## Site Plan Correction Request Form

Site Plan Case #: SP-03-0469C Correction #: 4 Expiration Date: 02/06/2007

Project Name: Harbison Auto Sales

Re: Request for Site Plan Correction to Harbison Auto Sales  
Case #: SP-03-0469C (Cor #: 4)

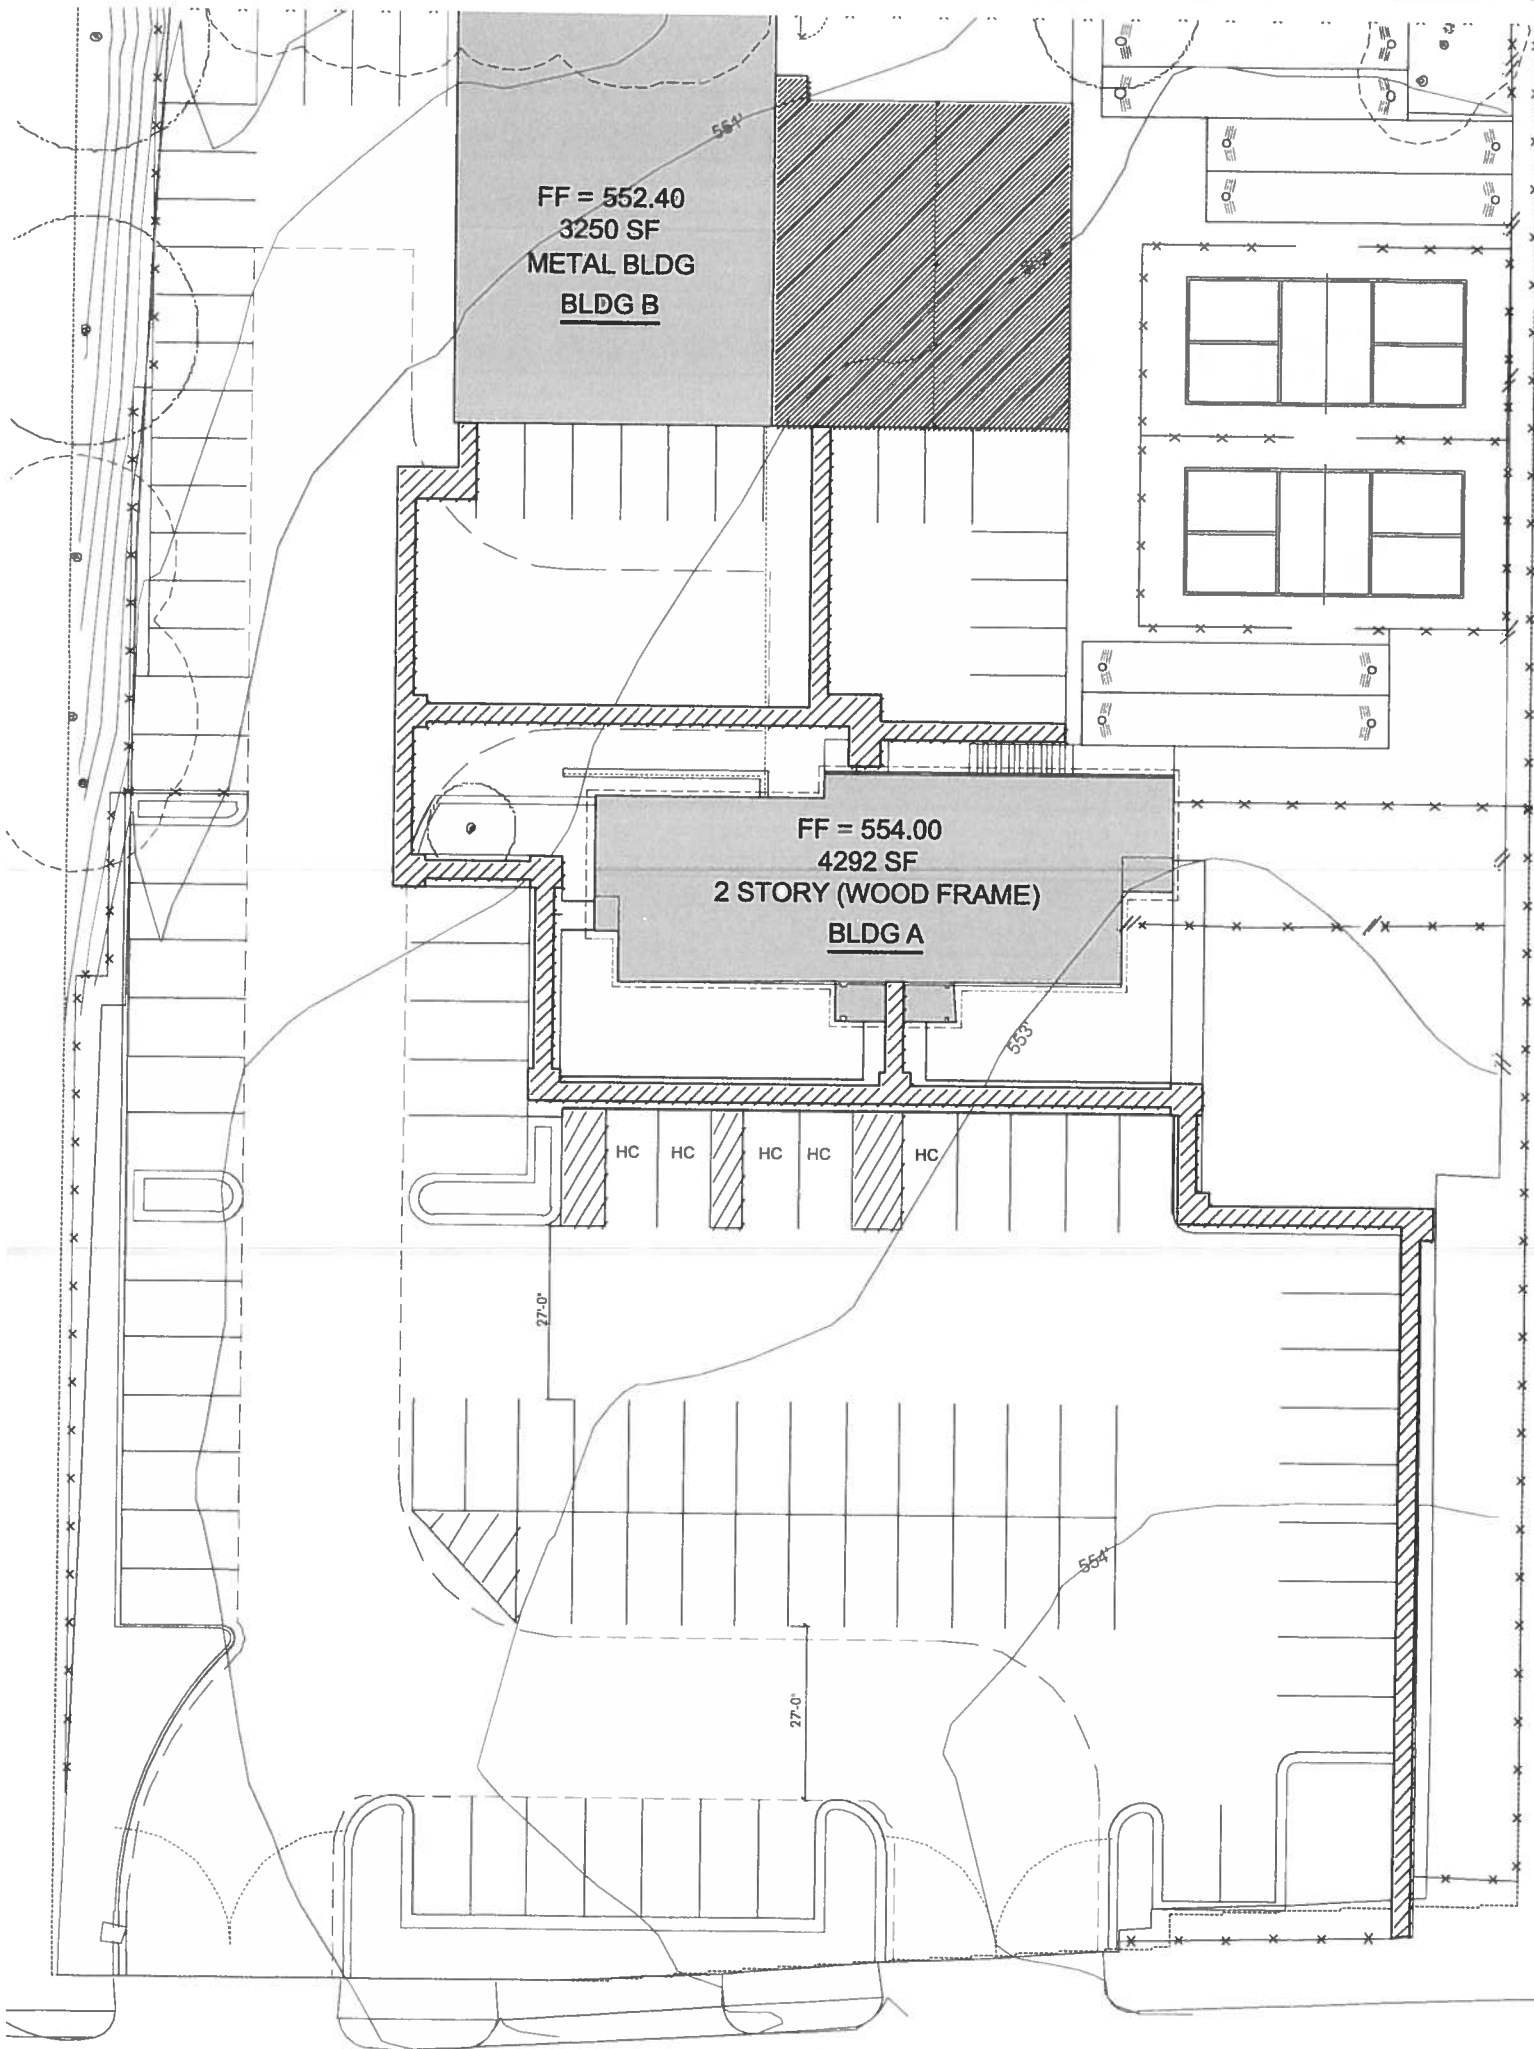
SP; Patio size on plan differs from parking table. Clarify and correct as needed. Condition storage area must be independently accessible from common space if parked separately from restaurant use. Condition Remodel only. Demolition of buildings may subchapter E Compliance. New accessible path running parallel to drive aisles must be protected by curb and gutter or bollards. (Viktor Auzenne) 512-974-2941

**Sht 4**

- Change of use from Auto Sales to Restaurant General for 1<sup>st</sup> floor (2,637 s.f.) and Storage for 2<sup>nd</sup> floor (1,655 s.f.) for Bldg 1
- Designation of Outdoor Seating on Existing Paved Surface adjacent to Bldg 2;
- Convert portion of existing parking area to Outdoor Sports/Recreation Use (2 Pickleball and 6 Cornhole Courts);
- Restripe existing parking to add HC and compact spaces and accessible routes– revise Building and Parking Table.

*Response: Parking table and outdoor patio area adjusted on plans. Bldg 1(A), 2nd floor Storage Use has independent access via separate exterior stairwell. No demolition is proposed -- all existing buildings to remain. Wheel stops added along HC accessible routes to delineate and separate accessible route from perpendicular drive aisles.*

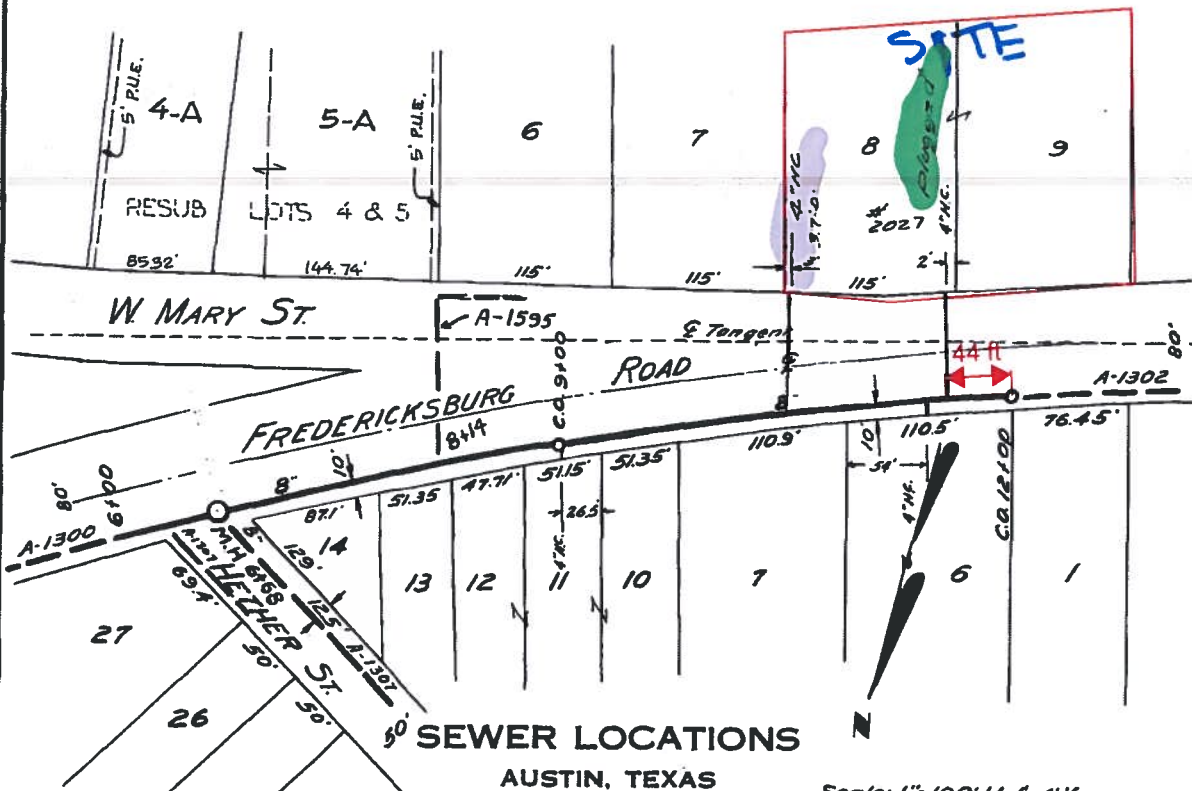
- The wastewater connection is in the northwest corner of the site and not the middle of the site, as currently shown on the Utility Plan. A copy of profile A-01351 shows the center wastewater connection is plugged. Field observations shows a 4" PVC to the corner of the site, as indicated on the attached red lines.
